**ITEM 2 PLANNING PROPOSAL – 21-23 VICTORIA AVENUE, CASTLE HILL
(4/2021/PLP)**

ITEM 2	PLANNING PROPOSAL – 21-23 VICTORIA AVENUE, CASTLE HILL (4/2021/PLP)
THEME:	SHAPING GROWTH
MEETING DATE:	10 OCTOBER 2023
	COUNCIL MEETING
GROUP:	SHIRE STRATEGY
	SENIOR TOWN PLANNER
AUTHOR:	LAURA MORAN
RESPONSIBLE OFFICER:	MANAGER – FORWARD PLANNING NICHOLAS CARLTON

This report provides a summary and assessment of the planning proposal applicable to land at 21-23 Victoria Avenue, Castle Hill. The planning proposal is being reported to Council for a decision on whether or not to submit the planning proposal to the Department of Planning and Environment (DPE) for Gateway Determination.

Figure 17

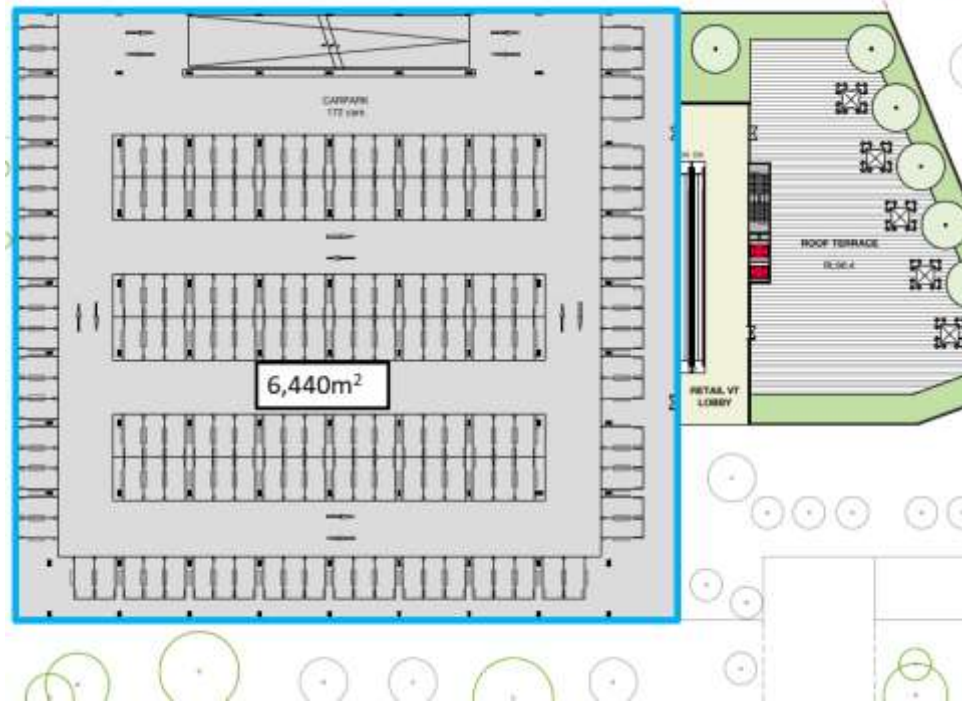
Given the flooding constraints, overland flowpath and Council stormwater assets which constrain development of this particular site, it is reasonable to concede that the Proponent would have no option but to accommodate some of the parking areas above ground. However, it is recommended that

to control the extent of this (and subsequent impact on the built form), the site specific DCP will also include additional controls that limit the maximum number of above ground car spaces on this site to 344.

Figure 5

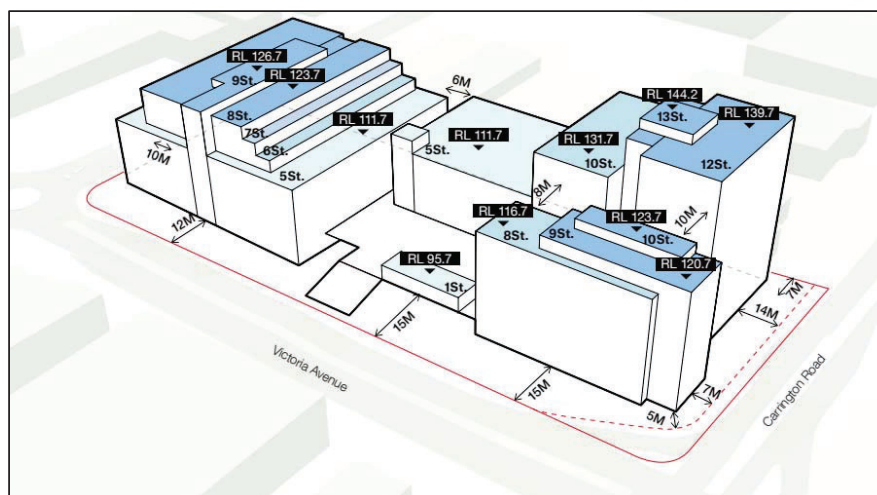
A portion of the southern corner and boundary of the site adjoining the intersection of Carrington Road and Victoria Avenue is zoned as SP2 Local Road Widening, for the upgrade and signalisation of this intersection. Since the land was identified for this purpose, further work has been progressed by Council with respect to the preliminary design of the intersection, including the provision of a slip lane along the southern corner of the site. This requires more land take from the subject site than is currently identified on the land zone map. The Proponent has sought to accommodate this revised boundary within their plans, though it is noted that reduced building setbacks are proposed to the revised boundary,

shown in the figure below. Should the planning proposal proceed, further negotiations with the Proponent would be required regarding the delivery of tangible public benefits in association with the uplift, such as dedication of the land required for the slip lane to Council at no cost.

Figure 11

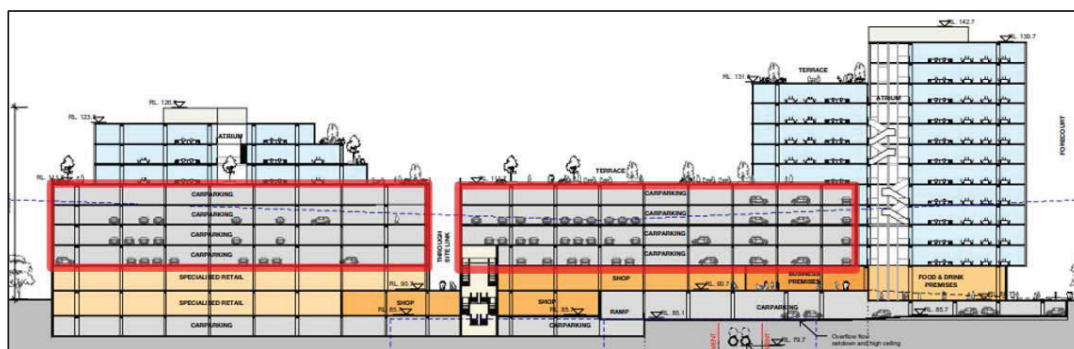
Specifically, the planning proposal seeks to facilitate approximately 54,961m² of gross floor area on the subject site, which equates to a floor space ratio of around 2.61:1. However, the development concept identifies the requirement for a further 40,000m² of 'floor space' within the building envelope, for the dedicated purpose of car parking (in addition to the gross floor area). As a result, the supporting development concept demonstrates a built form outcome that is far more substantial in terms of bulk and scale than would be expected for a development at 2.61:1, being more equivalent to a floor space ratio of 4:1.

To illustrate this, Figure 11 below shows a section plan of the development, identifying the extent of parking areas proposed to be located within the building envelope.

Figure 19
Section of development concept with potentially appropriate building forms outlined in blue

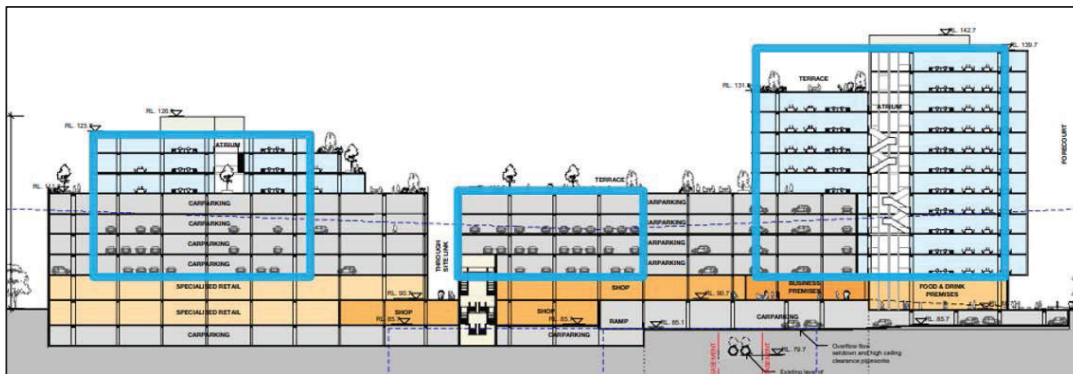
Council officers have marked up a diagram below to indicate potentially appropriate tower building envelopes that could result in a more acceptable built form outcome in this context of this site and the current and future character of the locality. It is noted however that this outcome would accommodate substantially less gross floor area (and associated parking areas) within the building envelopes in comparison to that being sought by the Proponent. The Proponent has previously been advised that consideration should be given to reducing the extent of FSR sought in order to relieve these built form issues.

Figure 24

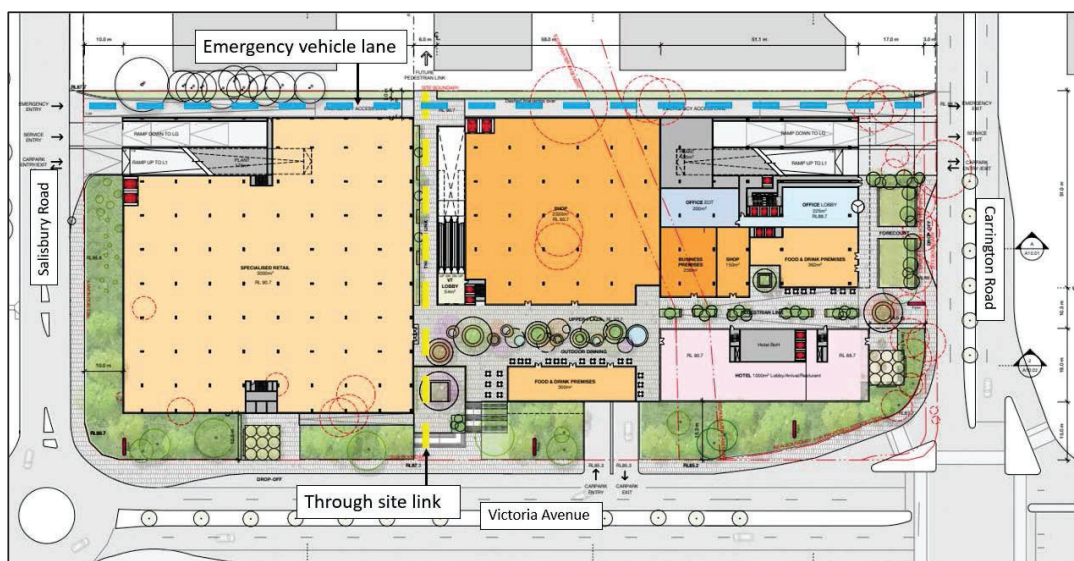
- The proposed through site link is inconsistent with the design criteria in the Showground Station Precinct DCP controls, including being clearly identifiable as a publicly accessible pedestrian link, encouraging pedestrians to move along the link and not linger; ensuring adequate passive surveillance is provided, having adequate lighting to improve safety and appropriate building setbacks.
- The through site link is intersected by a service/emergency access road along the rear boundary of the site, which will inhibit pedestrian movements and potentially be dangerous as pedestrians will interact with delivery, service or emergency vehicles.

Any revised proposal should provide a through site link that demonstrates consistency with the Showground DCP, is at grade, does not intersect with a service road, be accessible for people with a disability or in wheelchairs and be easily identifiable, welcoming and encourage pedestrian use. Further consideration and prioritisation of the through site link in the design of the development is needed to positively contribute to the pedestrian infrastructure and permeability. The management of the service land and its relationship with the through site link could potentially be addressed through measures such as timed service vehicle access or boom gates, however this would be a last resort to rectifying the site planning issues identified within this report as part of the planning proposal application. Furthermore, the viability of this type of arrangement would likely depend on the final make-up of uses within a future Development Application.
